# 360 BANDIT™

UPDATED SUPPORT STRAP  
WHITE 9000 MODELS

3.12.20 • V1

## UPDATED SUPPORT STRAP - WHITE 9000

### WHY UPDATE THE SUPPORT STRAP?

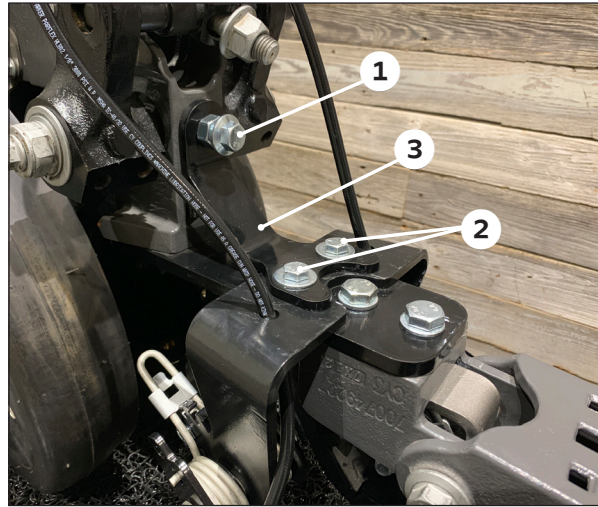
We have developed a different style of support bracket for BANDITS on White planters. This bracket provides more support for the closing system than the bracket provided with your BANDIT system last year.

If you have already fully installed your 360 BANDIT units on your planter, please follow these instructions to replace last years support strap with this new one.

#### RESECURE BANDIT ARM ASSEMBLY

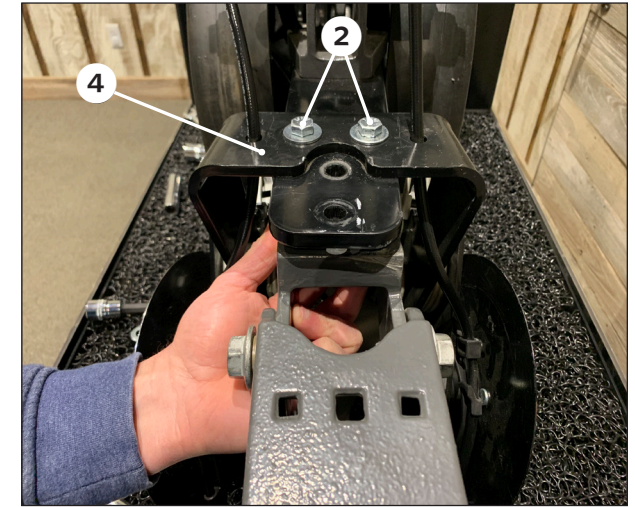
Keeping the BANDIT arm assembly in place **4** over the extension bracket and ensuring the BANDIT arms are facing the rearward direction, reattach the BANDIT arm assembly to the extension bracket using the (2) 3/8" x 1-1/2" bolts and 3/8" flange nuts **2** that were removed in the previous step.

### INSTALL BANDIT ARM ASSEMBLY & SUPPORT STRAP

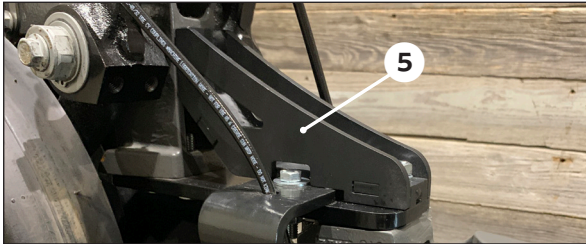
Place the new BANDIT support bracket **5** on top of the BANDIT extension bracket.

Using one of the longer bolts and a nyloc nut provided, attach the new support bracket and closing system to the second to last back hole in the BANDIT extension bracket **6**. The bolt should be inserted from the top and go through the support strap, extension bracket and then the closing system.

### RE-INSTALL CLOSING SYSTEM

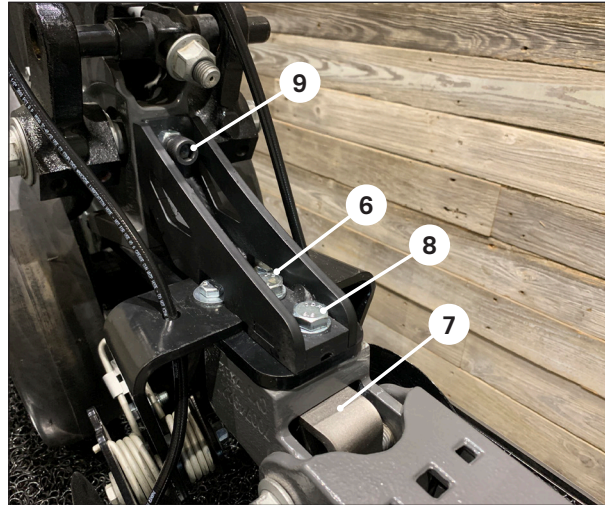
From the underside, maneuver the rock guard **7**, with the guard extension to the rear, around the two side closing system bolts and align the rock guard bracket with the rear most hole in the 360 BANDIT extension bracket.

From the top, install the provided bolt **8** through the new support bracket, extension bracket, closing system and rock guard. Secure with provided nut and tighten both bolts with 19 mm socket. Torque bolts to 42.2 ft lbs. **Ensure not to over tighten bolts.**

Thread the nut onto set screw. Install the set screw and nut in to top hole of the new support strap **9** and tighten the screw all the way down into threaded hole. Finally, tighten jam nut against support brace using socket.
